D117-762-041
Job Sheet 166643

Part Name: Replacement Skidtube

DART SERVICE INSTRUCTION

TO AMEND INSTALLATION INSTRUCTIONS IIN-D117-762 REV. E AND INSTRUCTIONS FOR CONTINUED AIRWORTHINESS ICA-D117-762 REV. 4

FIGURE 1 - GHL UPGRADE INSTALLATION

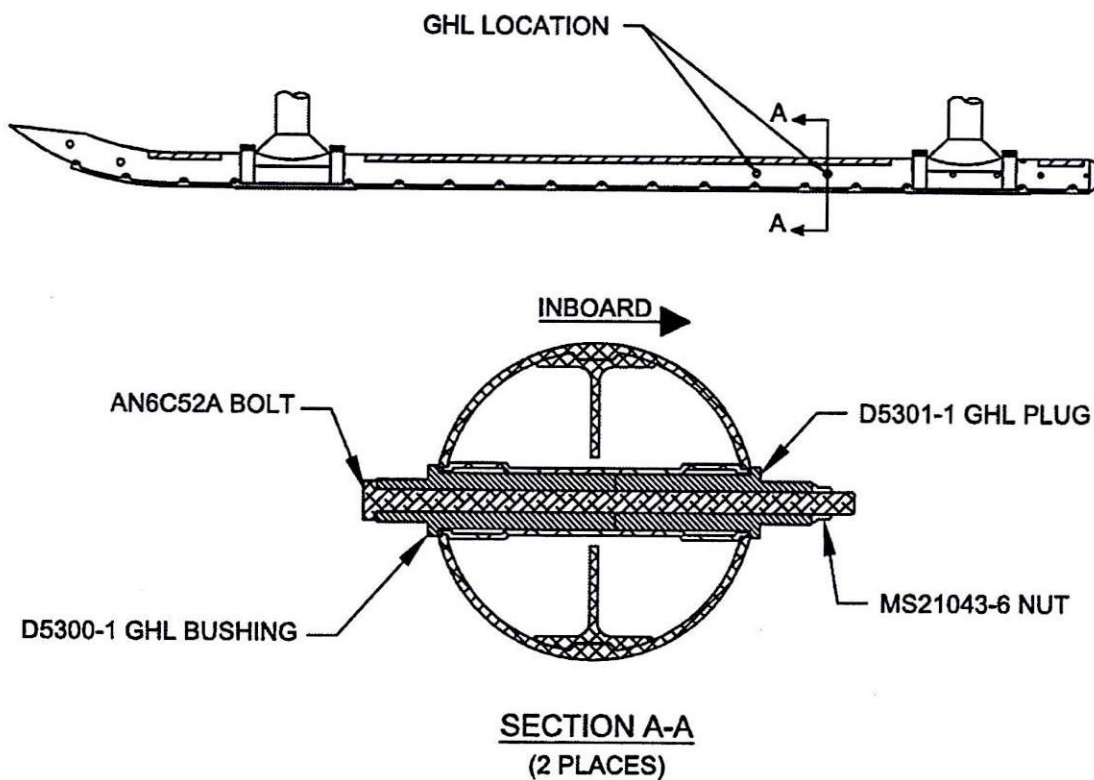
The purpose of this Dart Service Instruction (DSI) is to replace the ground handling lugs (D3864-1 Bushings, AN6C51A Bolts and MS21043-6 Nuts) on the D117-762-XXX Skid tubes with a structurally superior lug design (D5300-1 Bushings, D5301-1 Plugs, AN6C52A Bolts, MS21043-6 Nuts) as shown in Figure 1. The new hardware will be included in D117-762-011 @ CHG 004 and subsequent.

- 2.1 Loosely install (qty 2) D5300-1 GHL Bushing & (qty 2) D5301-1 GHL Plug wet with Proseal 890 or MIL-S-8802 Class B2 Sealant in location shown in Figure 1.
- 2.2 Install (qty 2) AN6C52A Bolts and (qty 2) MS21043-6 Nuts in accordance with Figure 1. Clean up squeezed out Proseal and apply fillet seal around D5300-1 & D5301-1.
- 2.3 Torque AN6C52A Bolts 160 - 190 in-lbs (18.1 - 21.5 N-m).

ITEM	QTY -011	PART NUMBER	DESCRIPTION
	X	D117-762-011	SKIDTUBE INSTALLATION
50	2	AN6C52A	BOLT
51A	2	D5300-1	GHL BUSHING
51B	2	D5301-1	GHL PLUG
52	2	MS21043-6	NUT

ITEM	QTY -011	PART NUMBER	DESCRIPTION
	X	D117-762-011	SKIDTUBE INSTALLATION
50	2	AN6C51A	BOLT
51	4	D3864-1	BUSHING
52	2	MS21043-6	NUT
